PROPOSED TECHNICAL SPECIFICATION CHANGE

SPOUYAH NUCLEAR PLANT UNITS 1 AND 2

(TVA-SQN-TS-91-16)

DESCRIPTION AND JUSTIFICATION FOR  
REVISION OF ACTIONS FOR TABLE 3.3-3

3/4 3-21

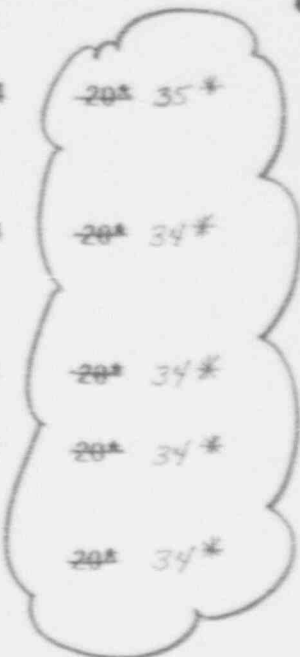
1. Start Diesel Generators	2/shutdown board	1 loss of voltage on any shutdown board	2/shutdown board	1, 2, 3, 4	<del>20*</del> 35*
2. Load Shedding	2/shutdown board	1/shutdown board	2/shutdown board	1, 2, 3, 4	<del>20*</del> 34*

b. 6.9 kv Shutdown Board Degraded Voltage					
1. Voltage Sensors	3/shutdown board	2/shutdown board	2/shutdown board	1, 2, 3, 4	<del>20*</del> 34*
2. Diesel Generator Start and Load Shedding Timer	2/shutdown board	1/shutdown board	1/shutdown board	1, 2, 3, 4	<del>20*</del> 34*

3. SI/Degraded Voltage Enable Timer	2/shutdown board	1/shutdown board	1/shutdown board	1, 2, 3, 4	<del>20*</del> 34*
8. ENGINEERED SAFETY FEATURE ACTUATION SYSTEM INTERLOCKS

ACTION 34 - a. With the number of OPERABLE channels one less than the Total Number of Channels, restore the inoperable channel to OPEPABLE status within 48 hours or be in at least HOT STANDBY within the next 6 hours and in COLD SHUTDOWN within the following 30 hours.

b. With the number of OPERABLE channels less than the Total Number of Channels by more than one, declare the associated 6,900-volt shutdown board inoperable, and comply with the action requirements of Specification 3.8.2.1 or 3.8.2.2 as applicable.

ACTION 35 - With the number of OPERABLE channels less than the Total Number of Channels by one or more, declare the associated diesel generator set inoperable, and comply with the action requirements of Specification 3.8.1.1 or 3.8.1.2 as applicable.
